UNITED STATES PATENT AND TRADEMARK OFFICE

APPLICATION NO.	FILING DATE	FIRST NAMED INVENTOR	ATTORNEY DOCKET NO.	CONFIRMATION NO.
09/971,763	10/09/2001	Moo-youl Kim	P56598	4212

## Office Action Summary

**FIG. 17**

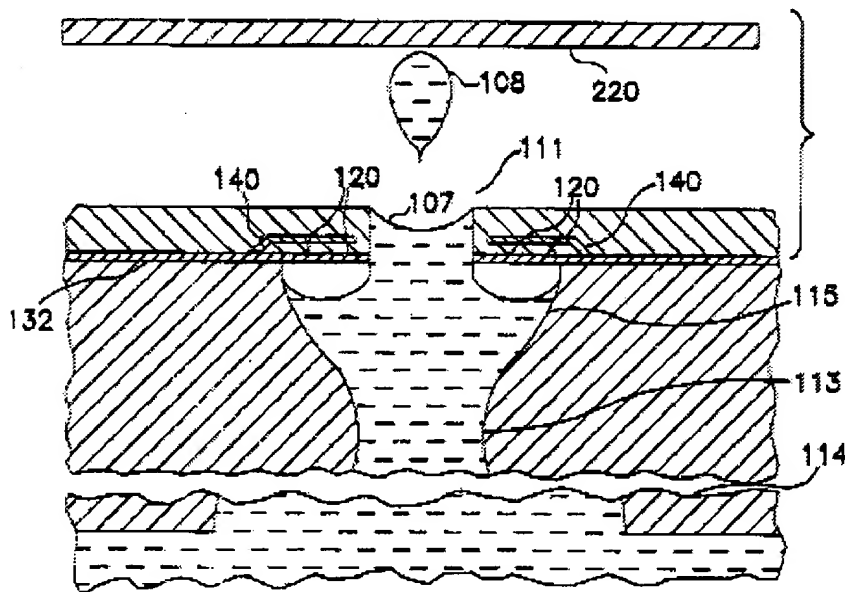
Silverbrook teaches (Fig. 17, above) an ink jet print head comprising a base plate (130), which is perforated by an hour-glass shaped structure having a hemispherical shaped top portion that is filled with ink, a nozzle plate that is mounted on the base plate and is perforated by a plurality of orifices in communication with their respective

chambers, a plurality of dough-nut shaped heaters (120) disposed on the underside of the nozzle plate and surrounding each nozzle and a plurality of ink inlet passages (113), which supply ink from a reservoir to the hemispherical hour-glass shaped chamber. As can be seen Fig. 18 (which is a reverse structure of Fig. 17), each hemispherical chamber is connected to a funnel shaped chamber (489). Since Fig. 18 is a reverse of Fig. 17, these funnel shaped chambers would be found beneath the hemispherical chambers of Fig. 17.

Silverbrook teaches the claimed invention with the exception of the ink inlet passages each having a plurality of grooves formed at an inner wall, the plurality of grooves extending through the base plate, the plurality of grooves being formed over an entire portion of said inner wall and the plurality of grooves extending in a direction parallel to a direction through said substrate.
